URGENT Field Safety Notice

Allura Xper, Allura Centron, and Azurion Systems: PC Issues
 Potential Loss of System Functionality which May Result in Delay or Termination of Procedure

28-December-2023

Reference: 2023-IGT-BST-027: Allura Xper, Allura Centron, and Azurion Systems: PC Issues Potential Loss of System Functionality which May Result in Delay or Termination of Procedure

Appendix B – Cold Restart Instructions & Symptoms

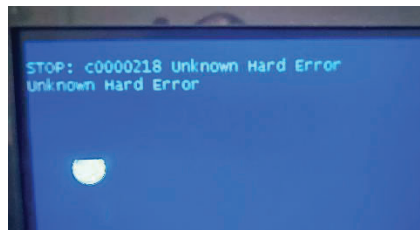
Perform a cold system restart every day before starting the first procedure, as follows:

- a) On the Review Module, press and hold “Power Off”.
- b) Release the button when the indicator light begins to flash.
- c) When the indicator light stops flashing, wait for 10 seconds.
- d) On the Review Module, press and hold “Power On”.

NOTE: Do not operate any of the controls while the system is powering on, as this may inhibit the start-up process.
